Non-Concurrence Process Record for NCP-2012-001

NCP TRACKING NUMBER
NCP-2012-001

TITLE OF SUBJECT DOCUMENT DIABLO CANYON POWER PLANT - INSPECTION REPORT 05000275/323-2011005	ADAMS ACCESSION NO. <i>ML 120450843</i>
---	--

Background: The purpose of this document is to provide detailed comments and context associated with Non-concurrence Package 2012-001 (ADAMS ML12151A173) because the topics discussed in NCP-2012-001 were complex and not fully explained. The action taken in response to NCP-2012-001 was to indicate that the NRC would address the operability question through a change to the current licensing basis, not through the enforcement process as proposed. However, as the branch chief responsible for Diablo Canyon Power Plant, I felt it was important to provide additional information on some of the details raised in NCP-2012-001 so that readers would have additional perspective on the issues and be able to recognize that the details described in NCP-2012-001 were reviewed, understood, and considered prior to taking action on NCP-2012-001. The following was cut and pasted from the original NCP-2012-001 (without the diagrams), and has not been altered except to include comment

Figure 1
Comparison of DE, DDE, & HE Horizontal Response Spectrum at the Steam Generators

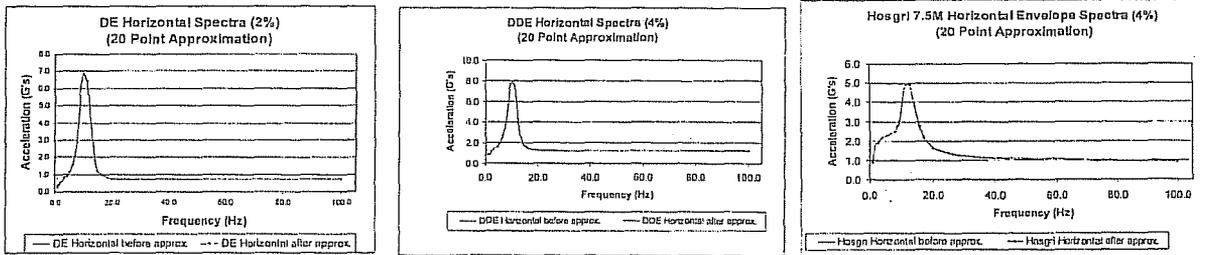
The licensee's substitution of the HE design basis for demonstrating the DDE Code acceptance criteria were met was not an acceptance approach by either the licensee's operability procedure or the NRC operability guidance. This was a concern because in many cases, the reactor coolant pressure boundary stress was more limiting for the DDE than HE (see Figure 1).

Comment [n10]: The data in this graph was not verified as part of our review. However, the reader should understand that the three curves used different ground motion and different damping values in the separate calculations. As a result, the curve that used the largest ground motion shows the lowest acceleration. This demonstrates that the output of the calculations are sensitive to the damping value approved by the NRC.

Figure 2
Comparison of DDE and HE Containments Floor Response at 88 Foot

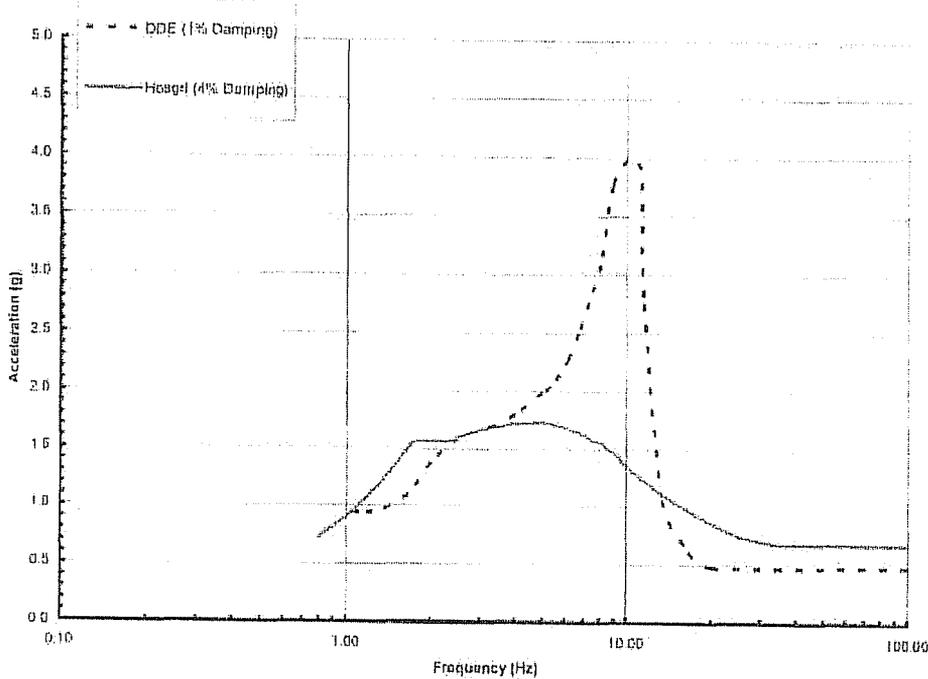
In many cases the DDE safety analysis provided the bounding vibratory motion used to establish the seismic qualification for plant SSC. For example, the FSARU credited the containment fan coolers to mitigate the design basis loss of coolant and steam line break accidents. The design basis required these coolers to be qualified to function following the vibratory motion (shaking) associated with the DDE. These coolers are located on the 88 foot level of the containment building. As shown in Figure 2, the DDE vibratory motion was greater than HE at this location. The POD was inadequate because the licensee failed to

Comment [n12]: The data in this graph was not verified as part of our review. However, the reader should understand that the two curves used very different damping values in the separate calculations. As a result, the curve that seems to show the larger acceleration is associated with much lower ground motion than the other curve. A comparison of the two curves shown is not meaningful except to illustrate that the DDE can produce much larger calculational results than the much larger Hosgri Earthquake because the DDE used very conservative calculational values.
